SOLICITATION ADDENDUM

Date: **11/23/22**
Subject: **Rear Entry Conversion Van**
Solicitation Number: **6100057362**
Due Date/Time: **12/5/22/14:00**
Addendum Number: **2**

Possible Wheelchair Seating Positions

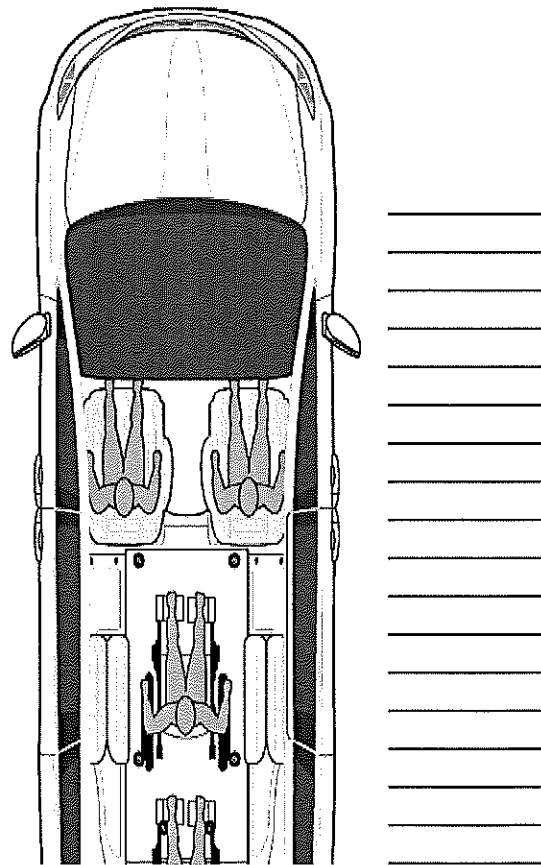
Page	Section	Request	Approval/Comment
		Due Date: Given that Request for Approved Equal questions are due 11/23 and a due date of 11/28, there is not enough time to properly react to the answers to those questions, please extend the due date one week.	
1	Specs	Transmission: Please approve Chrysler Voyager's 9 Speed Automatic Transmissions as approved equal.	Approved
2	Specs	Due to the chassis shortage/supply chain restraints, please remove the requirement for the Safety-Tech package. Including this spec will cause substantial delays.	Not Approved
2	Specs	Our standard conversion includes two single fold away seats (see the floor plan below. Please consider requiring this upgrade or approving it as equal.	Not Approved
